**EPC STORMWATER REVIEW COMMENTS
IN ORANGE BOXES WITH BLACK TEXT**

**PCD-ENGINEERING REVIEW COMMENTS
IN BLUE BOXES WITH BLUE TEXT**

THE HILLS AT LORSON RANCH FILING NO. 1

FINAL GRADING / EROSION CONTROL PLANS

DATE: JAN 18, 2021
PROJECT NO: 100.062
SHEET NUMBER: **C4.1**
TOTAL SHEETS: 16

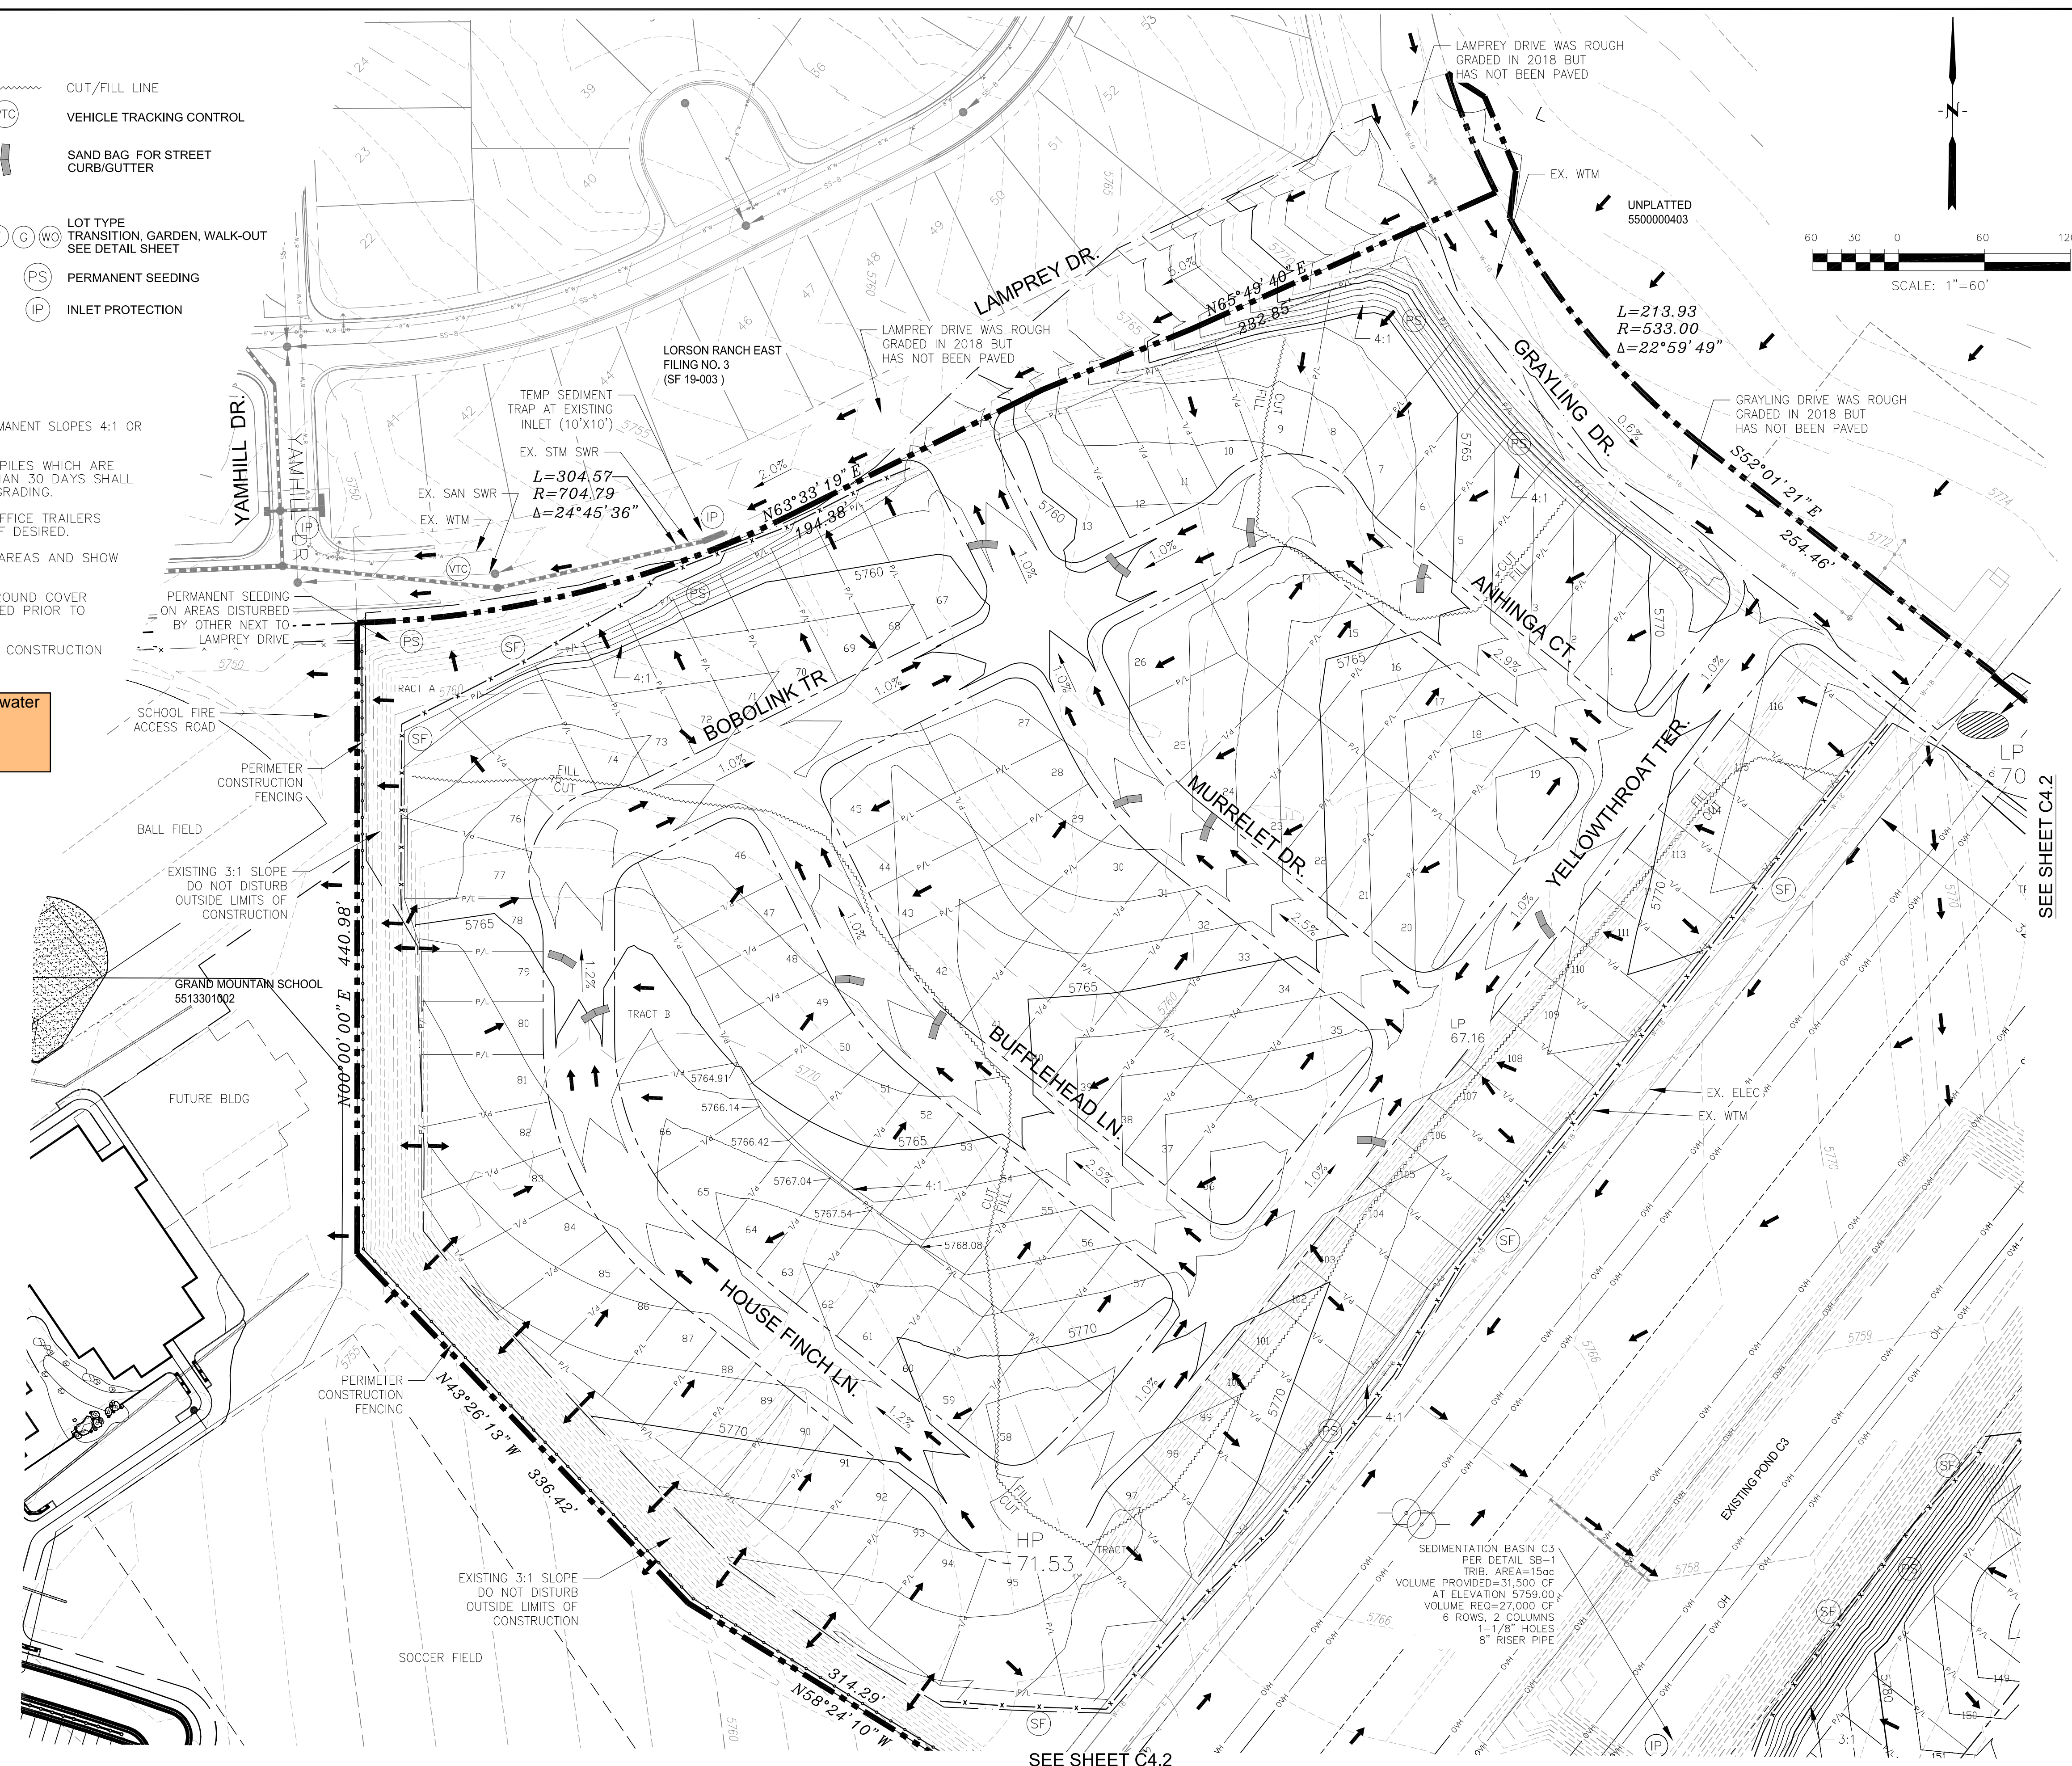
Final plat GEC Plan should show street curb & gutter, stormwater piping, and pond details for forebay and outlet structures.
Revise all sheets accordingly.

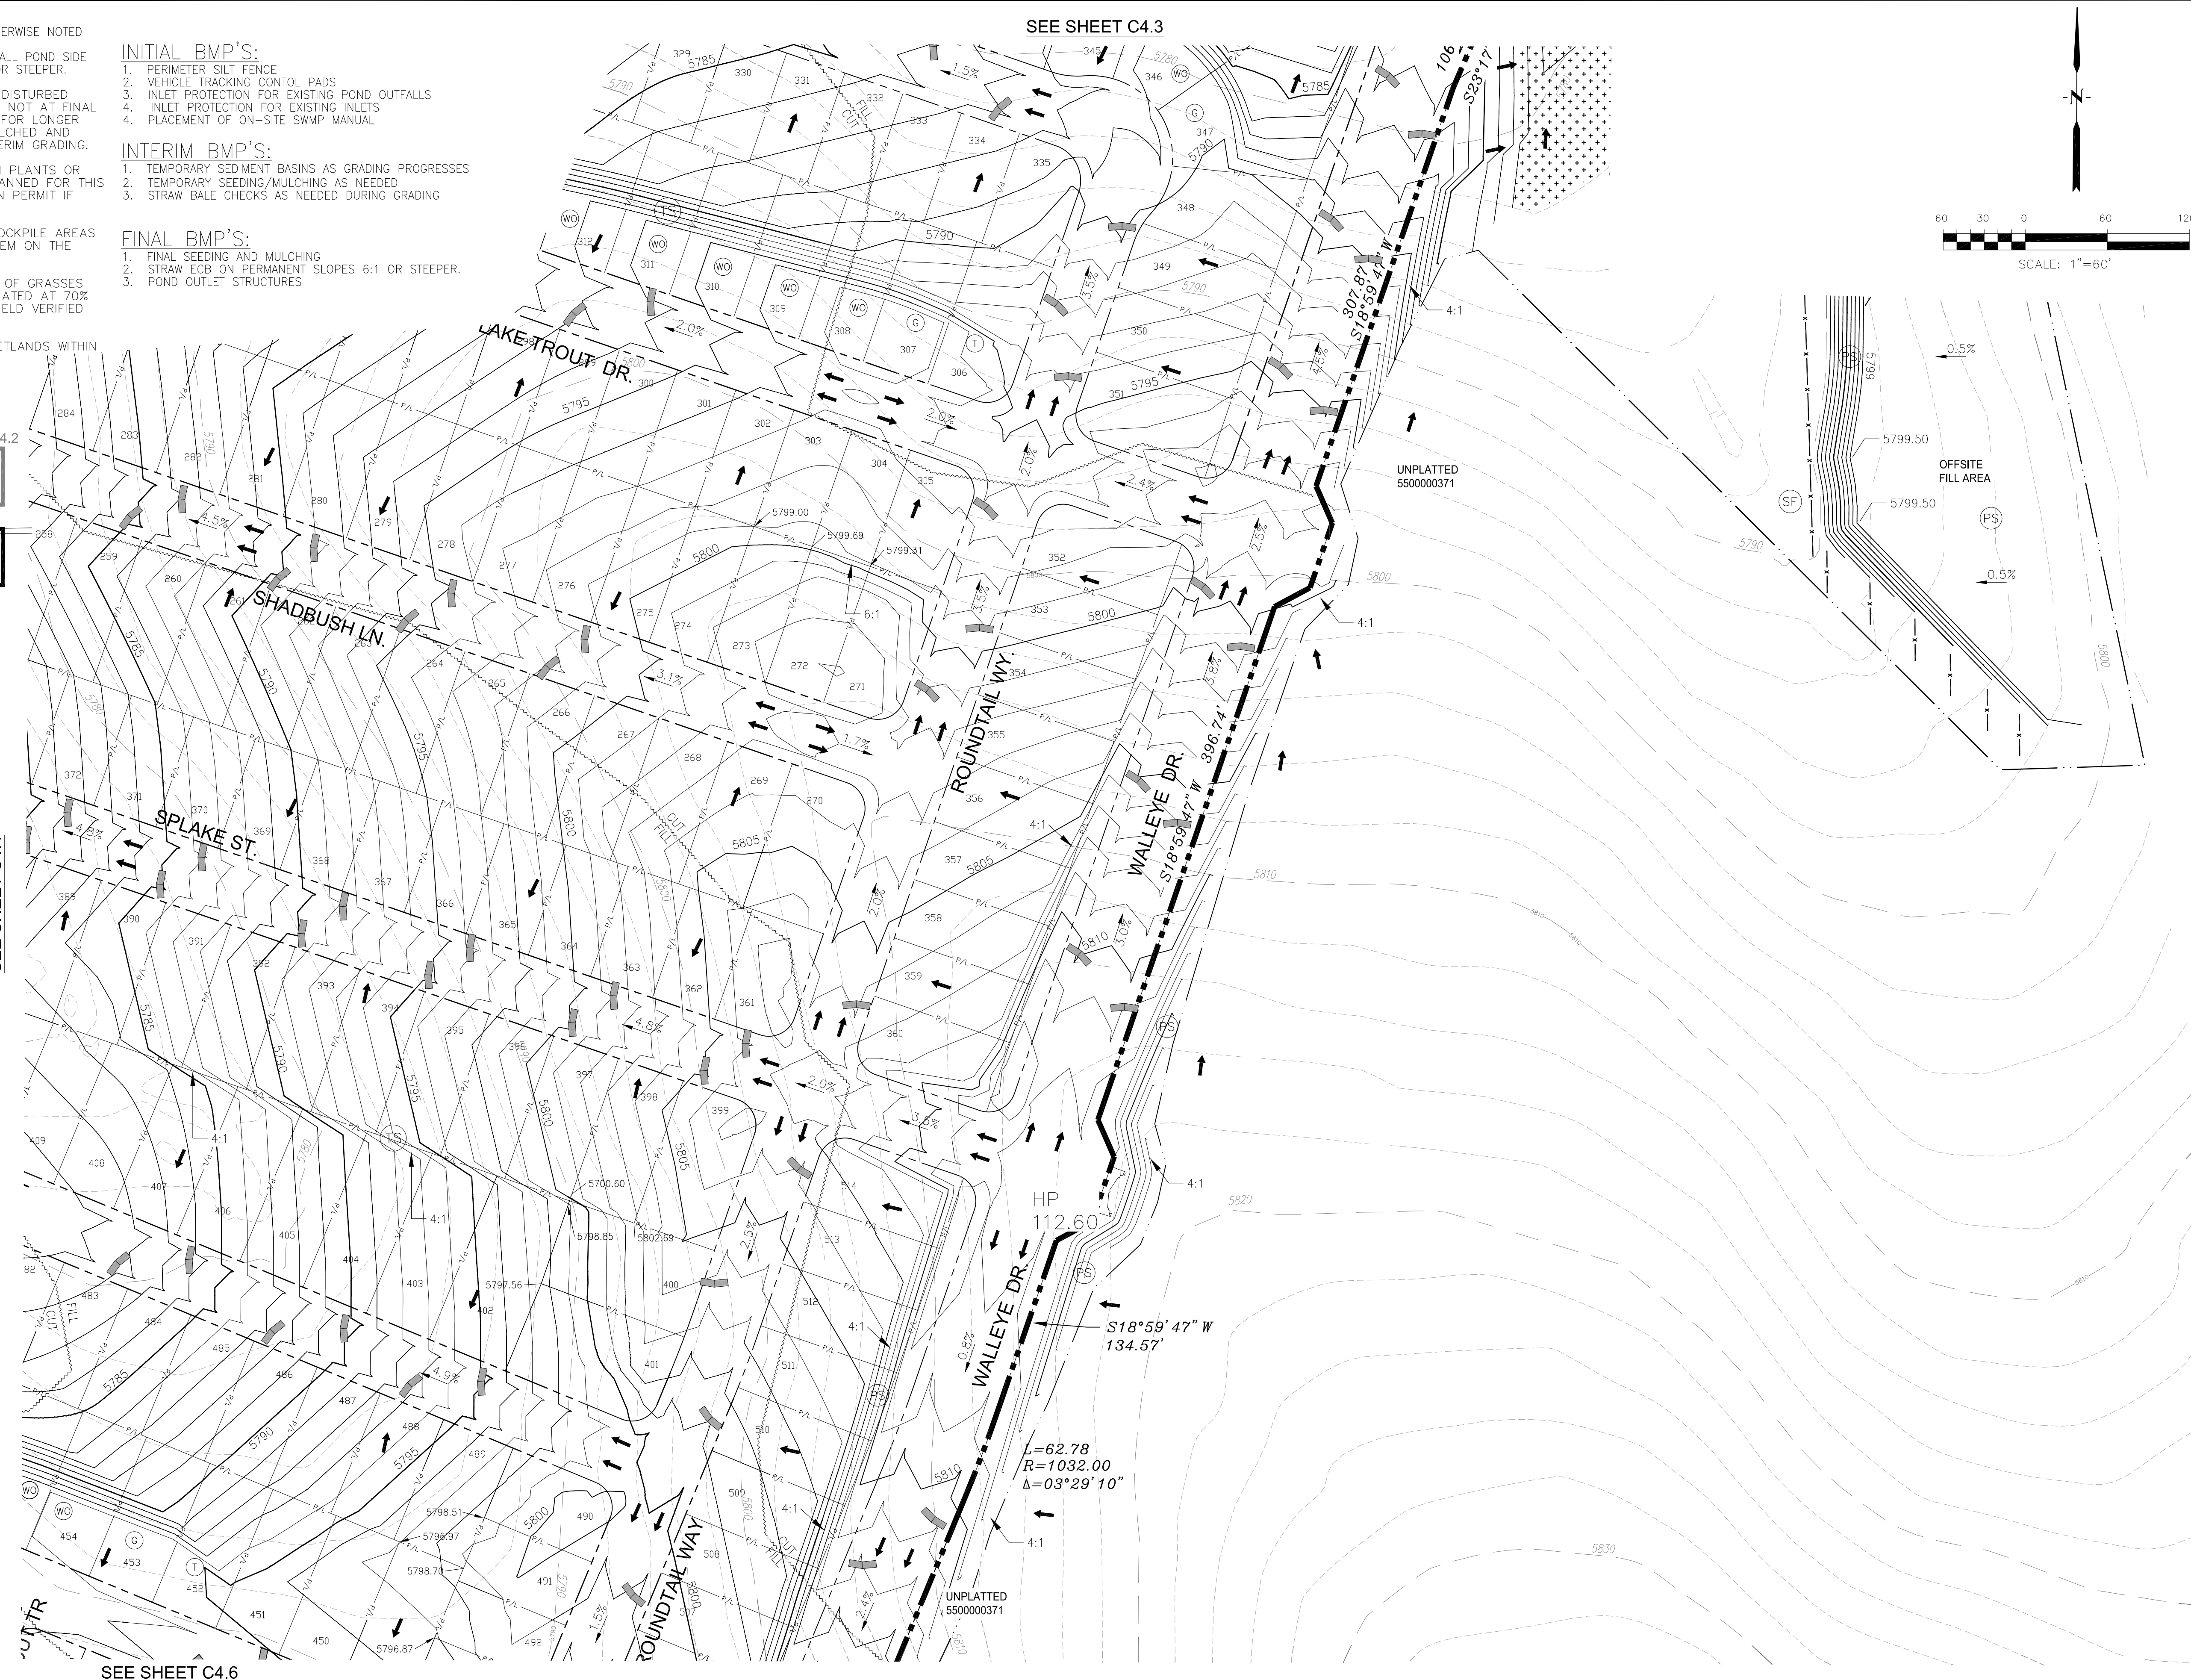
Label pond as existing?

Show and label emergency spillway for Pond C1, as mentioned on FDR page 43 of 227.
 Typical for all ponds.
 Size per UD-Detention spreadsheet.

SHEET NUMBER
C5.1

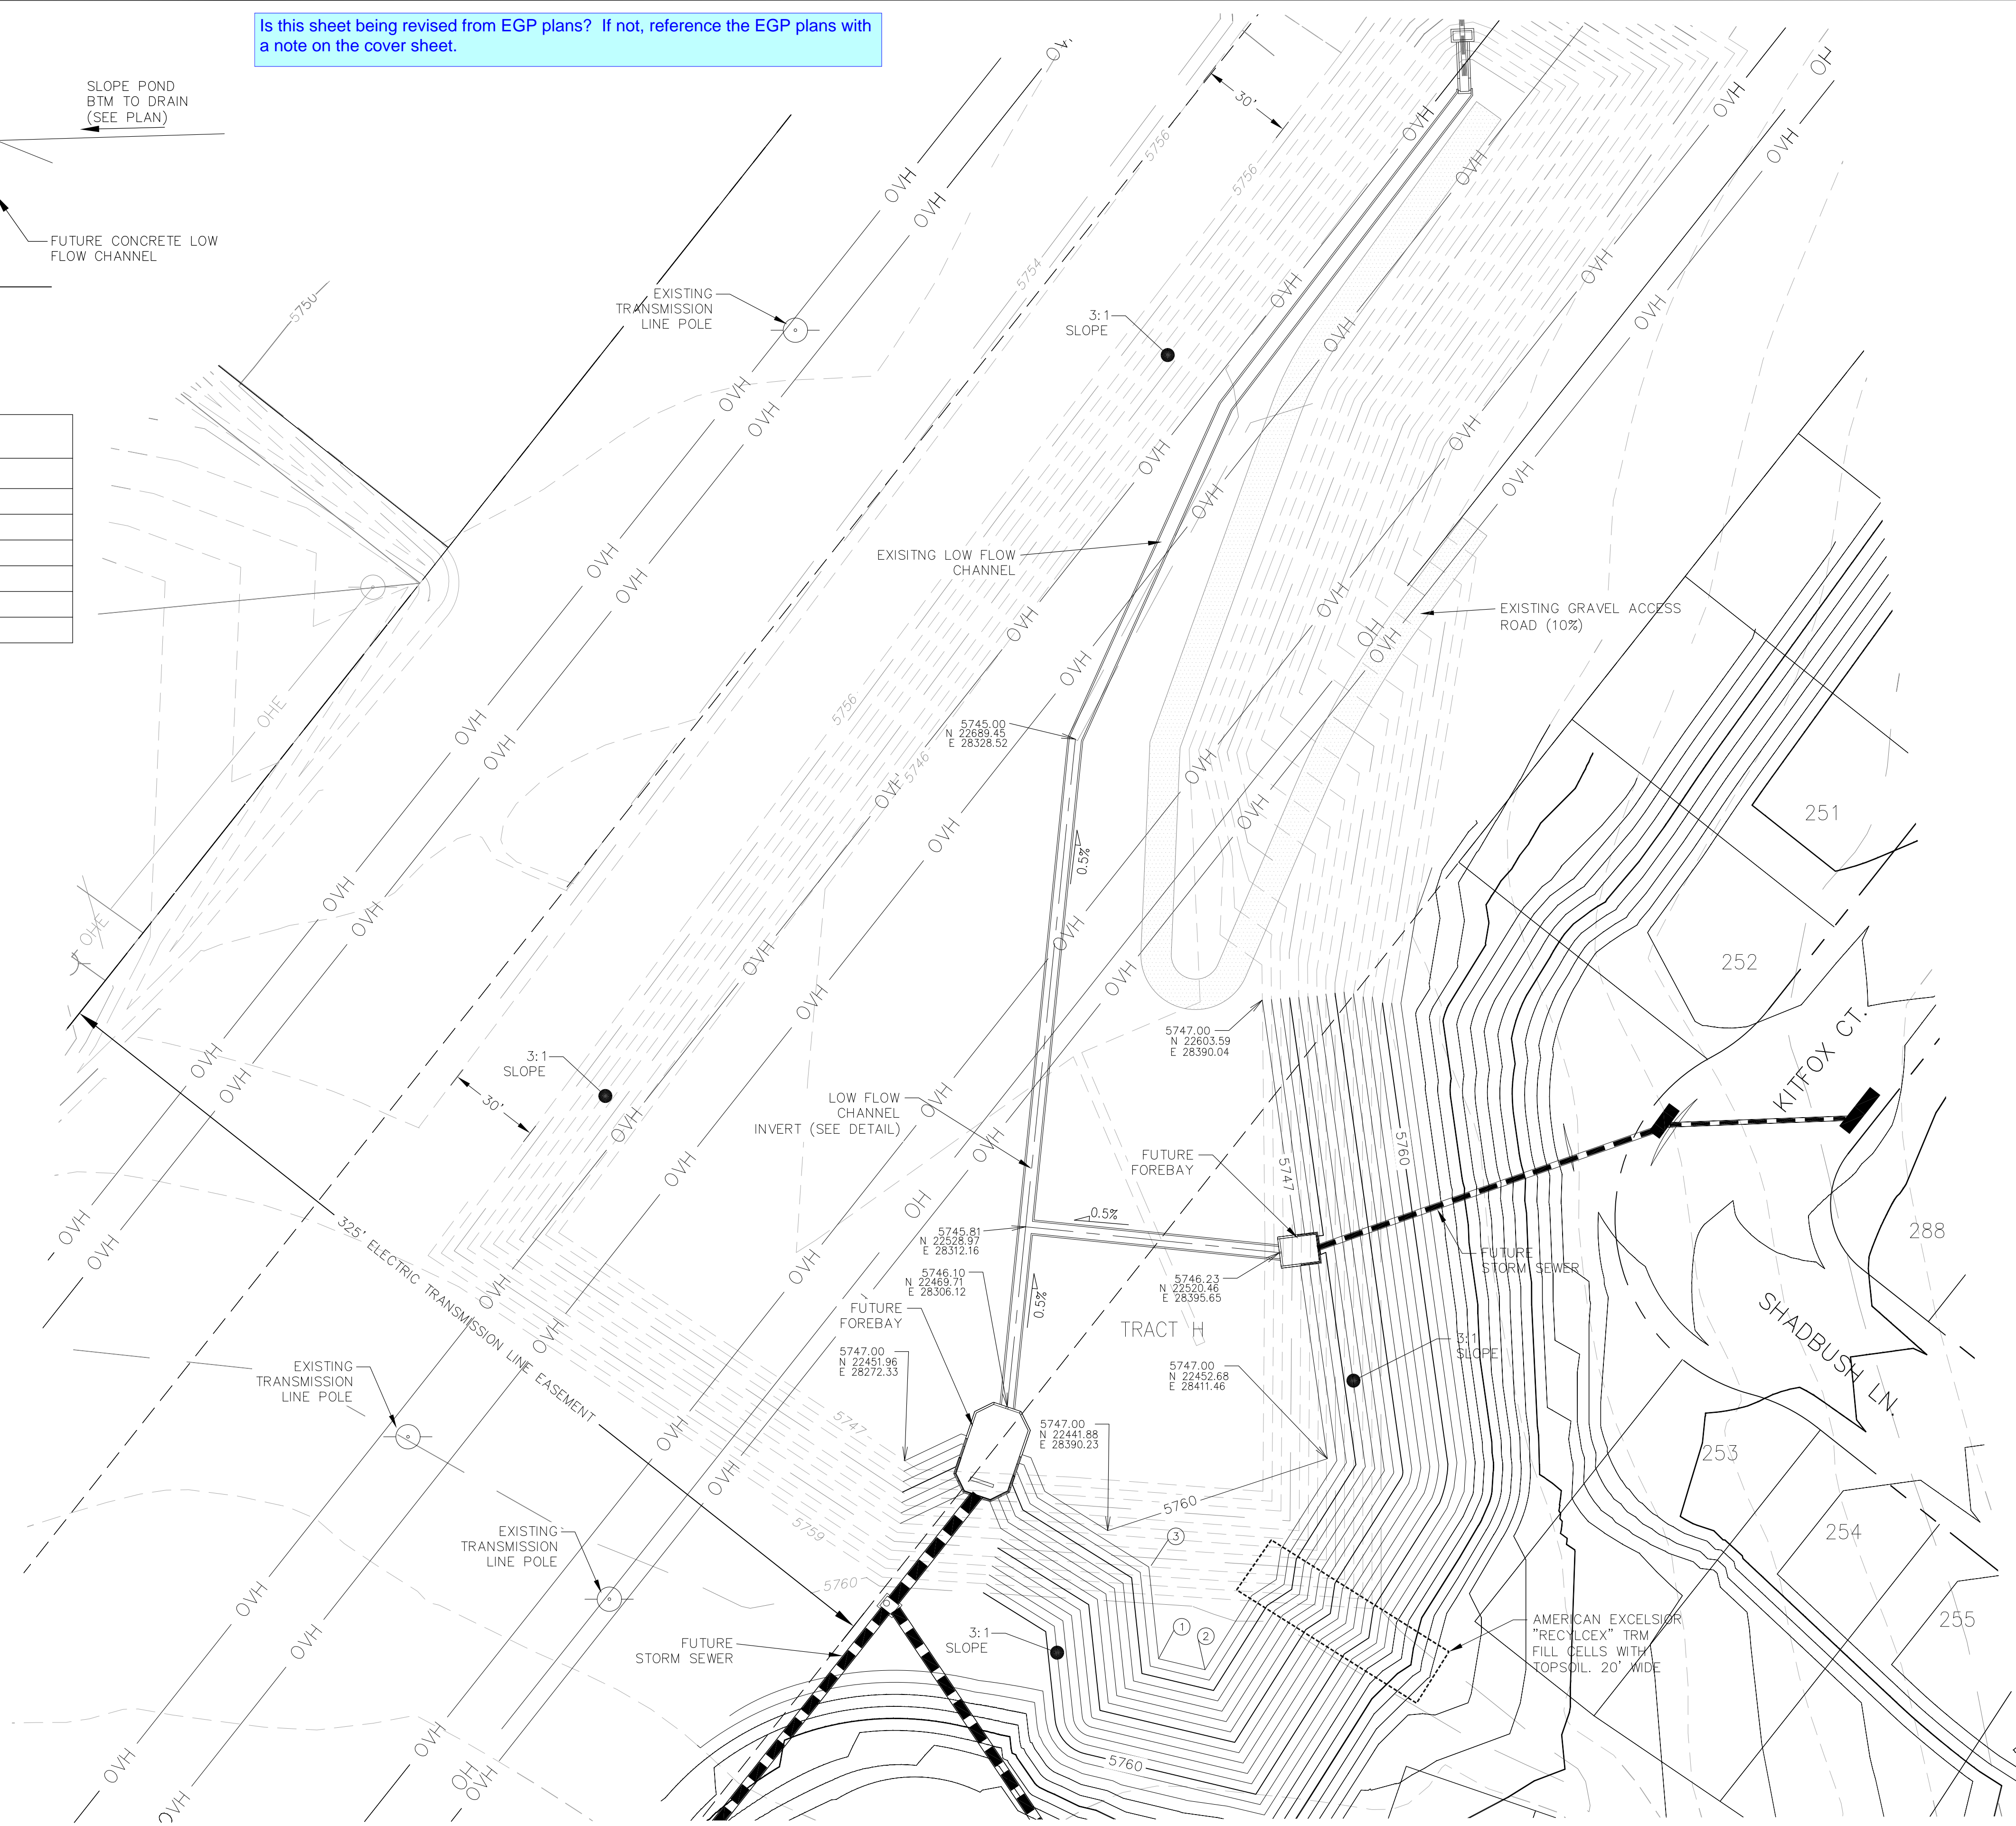
Is this sheet being revised from EGP plans? If not, reference the EGP plans with a note on the cover sheet.
